Planning Approval Consistency Assessment Form

Assessment name:	Change in location of Aerotropolis Core Station site
Prepared by:	[REDACTED]
Prepared for:	Sydney Metro, SBT and SSTOM contractors
Assessment number:	SM002
Status:	Draft
Version:	8.0
Planning approval:	SSI 10051
Date required:	February 2022
iCentral number:	SM-21-00431980
© Sydney Metro 2020

Description of proposal (change in location of Aerotropolis Core Station site)

Figure 1: Aerotropolis Core indicative construction site layout –approved project (SMWSA Submissions Report, 2021)

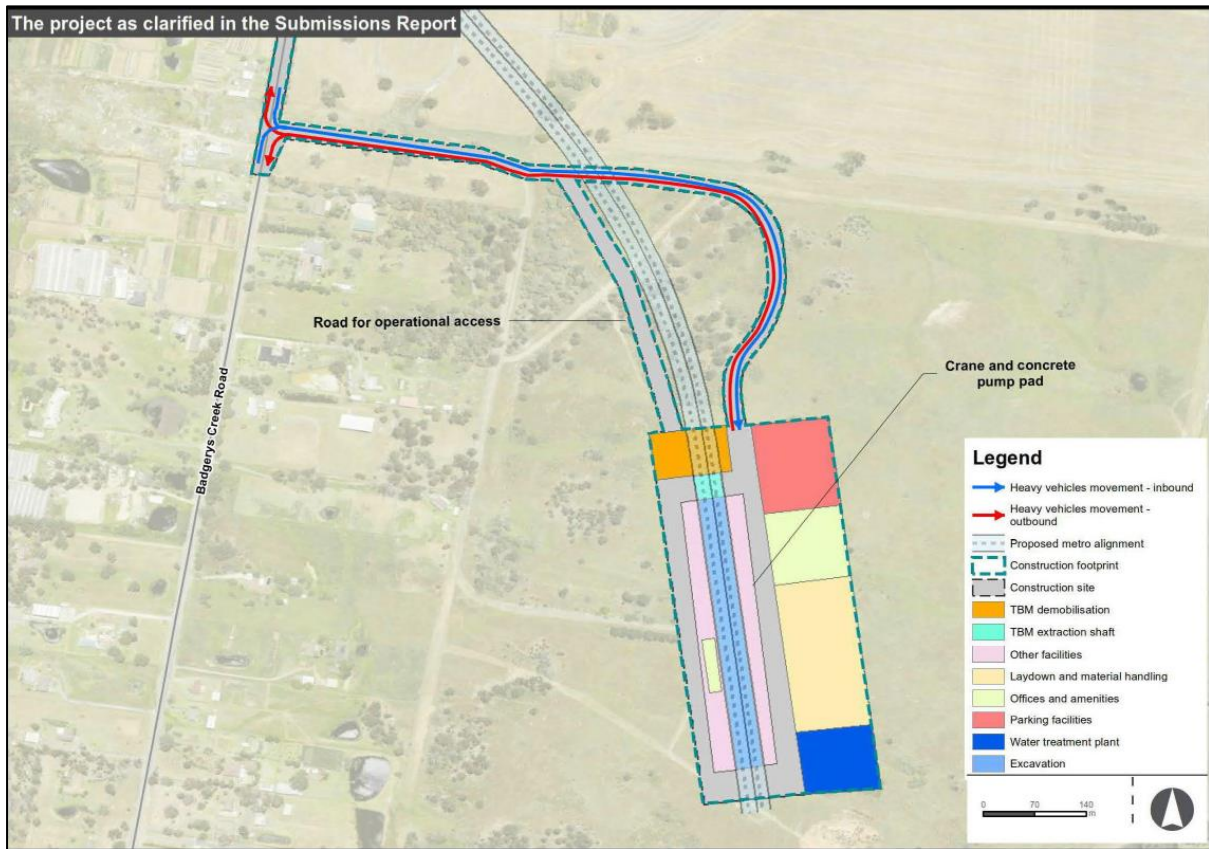
As a result of design development and construction planning and to allow greater flexibility in use of the site during construction, the proposed construction footprint at the Aerotropolis Core precinct was changed as discussed in Section 6.7 of the SMWSA Submissions Report. The proposed change, is shown in Figure 1 of Appendix A and includes:

- a revised construction footprint that retains some of the footprint proposed in the EIS and extends this predominantly to the east
- realignment of a section of the construction access road connecting the construction site to Badgerys Creek Road to minimise impact on mature trees
- inclusion of the proposed permanent access road within the construction footprint. This access road runs parallel to and immediately west of the rail alignment
- change to the indicative construction site layout as shown in the EIS. This revised layout is indicative only and would be subject to further design development, construction planning and ongoing consultation with the Western Parkland City Authority (WPCA).

Figure 2: Aerotropolis Core Station – Indicative layout and key design elements - approved project (SMWSA Submissions Report, 2021)

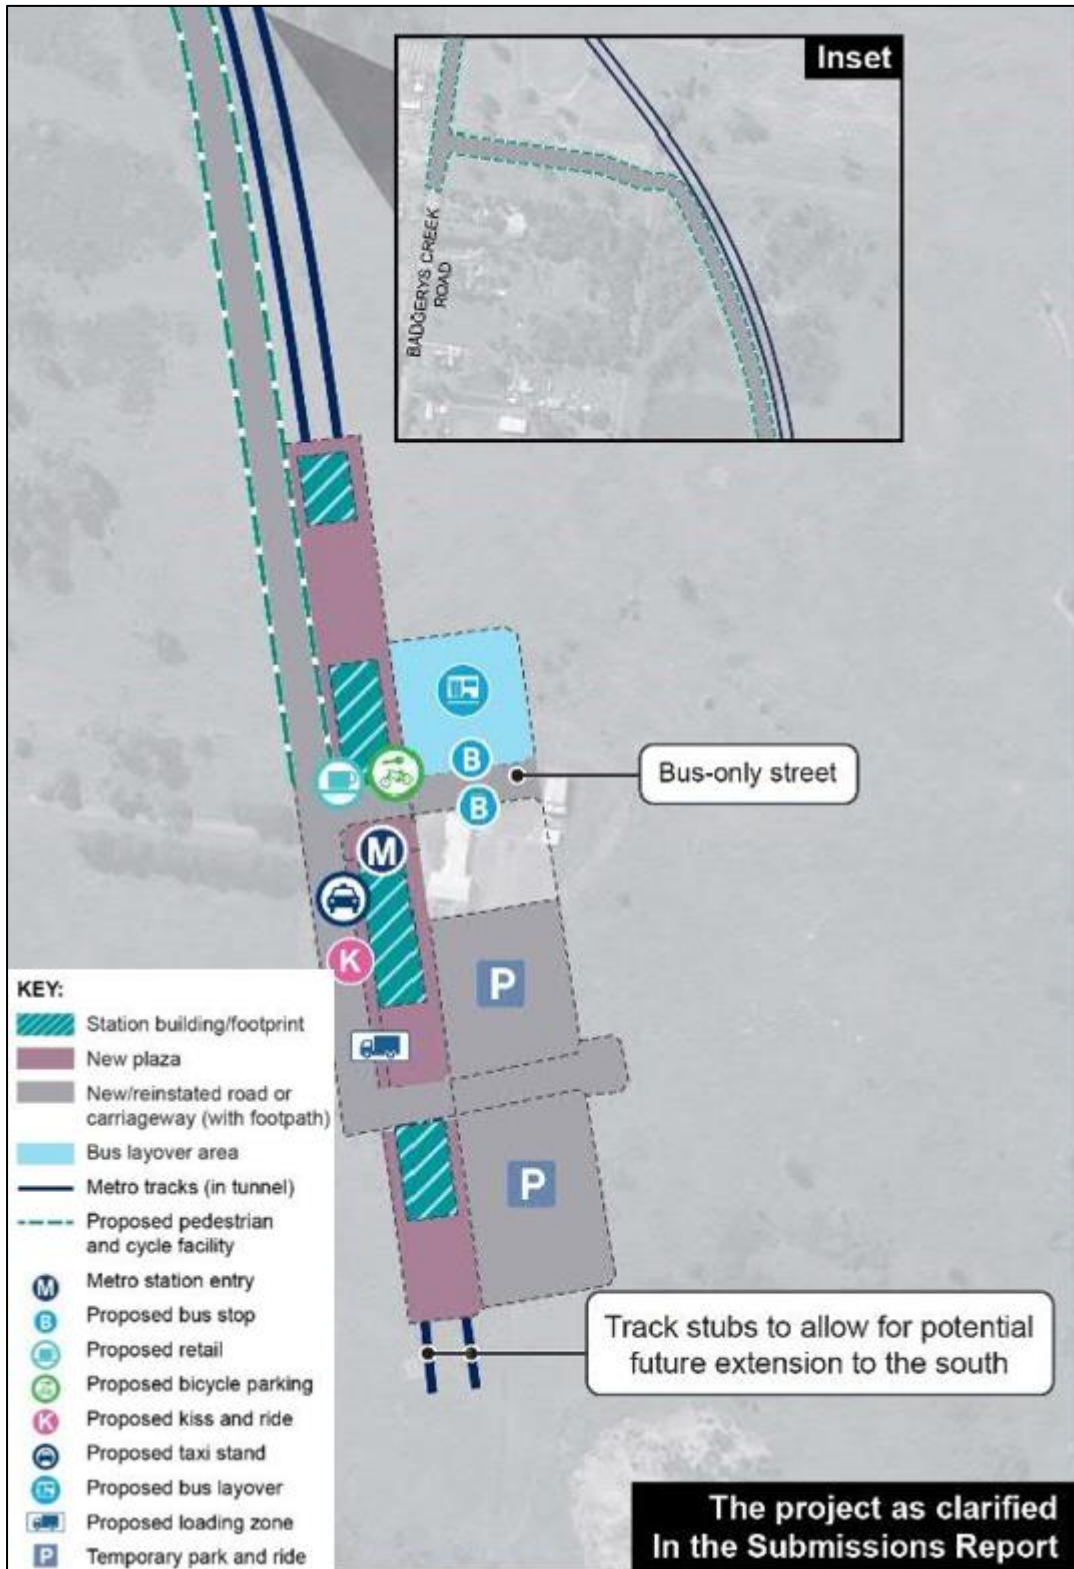
The proposed operational changes for the Aerotropolis Core Station site are shown in Figure 2 of Appendix A and include:

- construction of an additional road for operational access to the Aerotropolis Core Station
- revised location of the indicative operational layout and key design elements. This revised layout retains the same elements as assessed within the EIS.

Figure 3: Revised Aerotropolis Core indicative construction site location shown by a black dashed line compared to approved project.

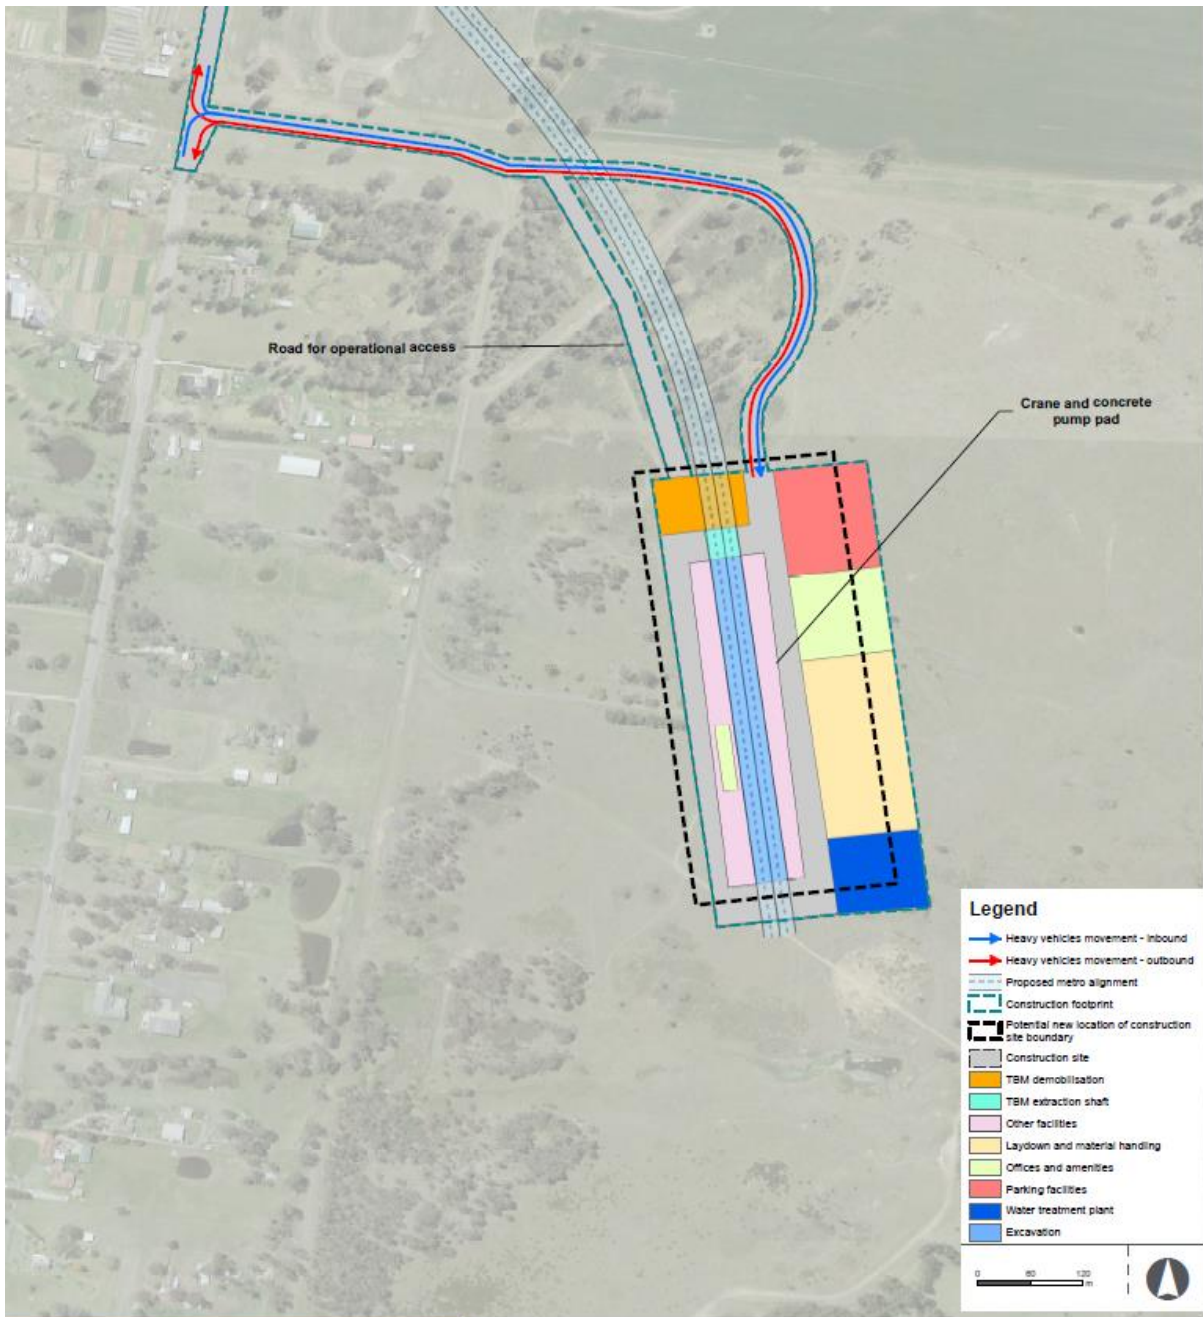
The Aerotropolis Core Station construction site boundary is proposed to move up to 20 metres to the north and up to 20 metres to the west to accommodate a move of the station box within the site by approximately 75 metres to the north. The revised location of the site is shown in Figure 3 of Appendix A.

- The general layout of construction activities within the construction site would remain unchanged other than the construction site boundary moving up to 20 metres to the north and up to 20 metres to the west
- The indicative layout and key design elements for the operational station precinct would remain unchanged other than the station box would move around 75 metres to the north.

Eleven options were developed for the Aerotropolis Core Station site and compared to the approved project location. The proposal (Option C1) which requires a move of the station box approximately 75 m north was identified as the preferred option. The movement of the station box requires an associated move of the Aerotropolis Core Station site as a whole by up to 20 metres to the north and up to 20 metres west.
